Submission to Transport for NSW

Newcastle Light Rail Review of Environmental Factors (REF) 2016 Newcastle City Council

27 May 2016

Figure 3 – Segregated Running along Hunter Street (TfNSW REF, 2016)

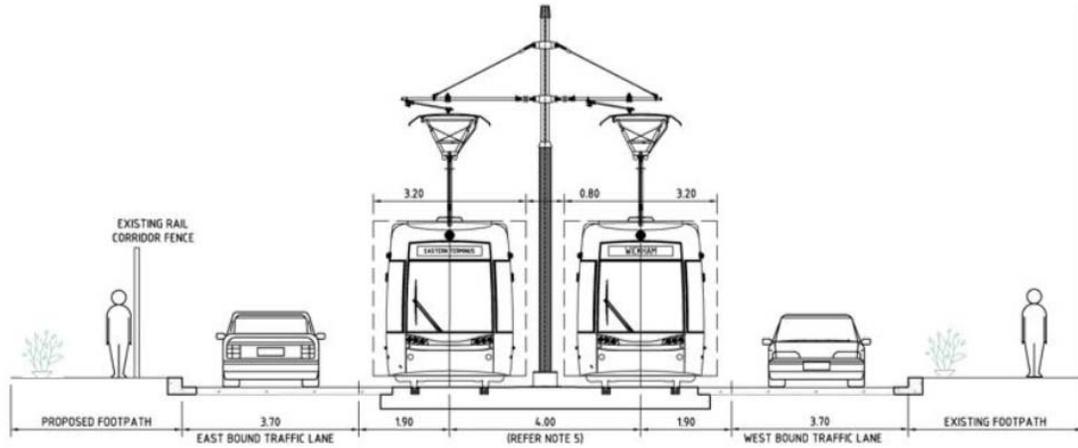
The separated running model described in the TfNSW REF will compromise the fabric and function of Hunter Street while removing any opportunity to provide cycle ways or accommodate pedestrian footpath widening along Hunter Street. This is illustrated in Figure 3 below:

It is evident in figure 3 above that no consideration is given to urban amenity and city operational issues such as pedestrian friendly design, footpath widening, cycleways, landscaping and parking. For the REF to identify that these critical issues will be addressed at a later date is an inappropriate response and is unacceptable to Council and the people of Newcastle.

Figure 6 – TfNSW versus NCC Preferred Operational Model for Light Rail

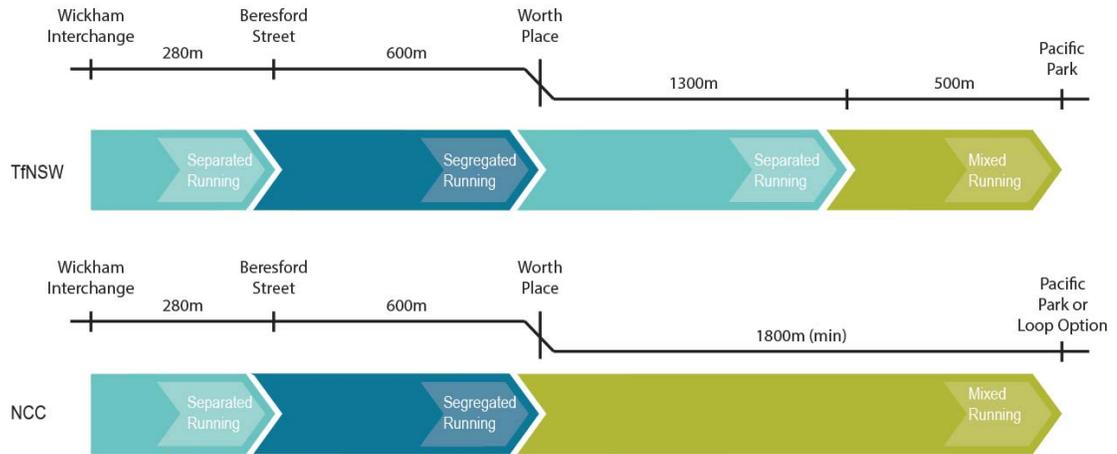
The operational model described in the TfNSW REF will involve 600 metres of segregated running within the heavy rail corridor from Wickham, followed by 1300 metres of separated running along Hunter Street, before a final 500 metres of mixed running within Scott Street. A comparison of the operational models is provided in Figure 6 below:

While the REF accepts mixed running for 500 m along Scott Street, its reasoning for discounting an additional section of mixed running along Hunter Street is unclear, lacks justification and has not been supported by a quantitative risk assessment. Section 5.5.2 of the TfNSW REF makes a comparison between mixed and separated running in an attempt to justify the 1300m of separated running along Hunter Street.
